Sent: 18/04/2020 5:48:58 PM
Subject: Fwd: DA 2020/0302 41 Upper Clifford Ave Fairlight
Attachments: Letter of objection - DA2020_0302 - Kulaga.pdf;

Re: Notice of Proposed Development NO: 2020/0302 41 Upper Clifford Avenue Fairlight.

Loss of privacy from lower level Unit 1 (below)

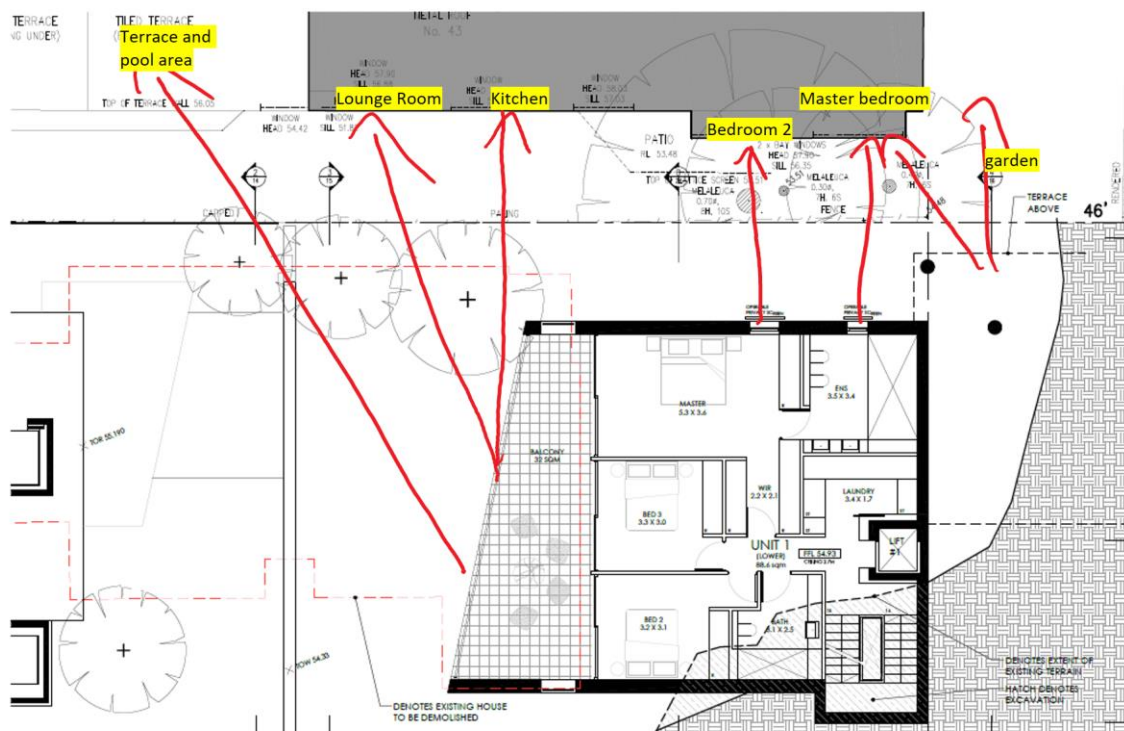
- Our kitchen, located along the western side of our apartment will be in the direct line of sight from the Unit 1 south facing terrace which with its current angle and orientation facing west will have direct eyeline straight into our kitchen, lounge and dining area from both its top and bottom floors;

- Our lounge room will also be in direct line of sight from the southern terrace of unit 1;
- Our front terrace and pool area will also be completely overlooked from the unit 1 south terrace;

Overall one of the primary concerns we have is the size and orientation of the southern facing terrace which is angled directly to our apartment in a western direction which causes substantial privacy issues raised above. Unfortunately, this will affect all of our primary living and sleeping areas of our home as shown below.

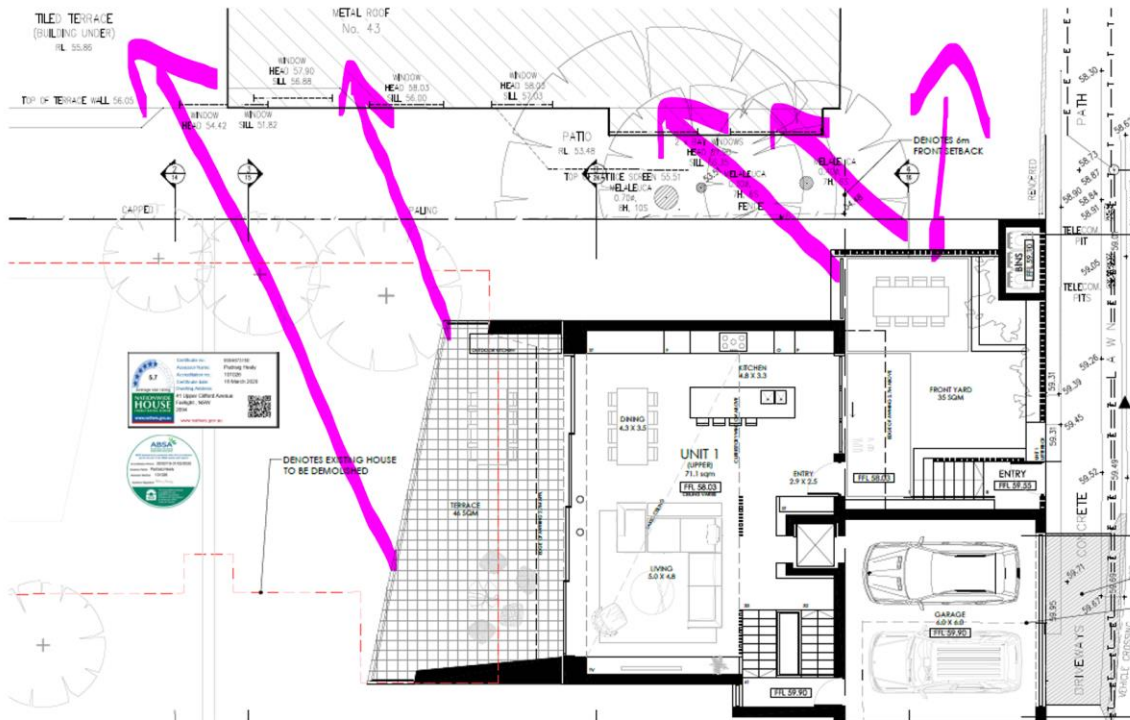
Red arrows below indicate the direct line of sight from the lower level of Unit 1 providing them the ability to view directly through to our terrace, lounge, kitchen, 2nd bedroom, master bedroom and garden.
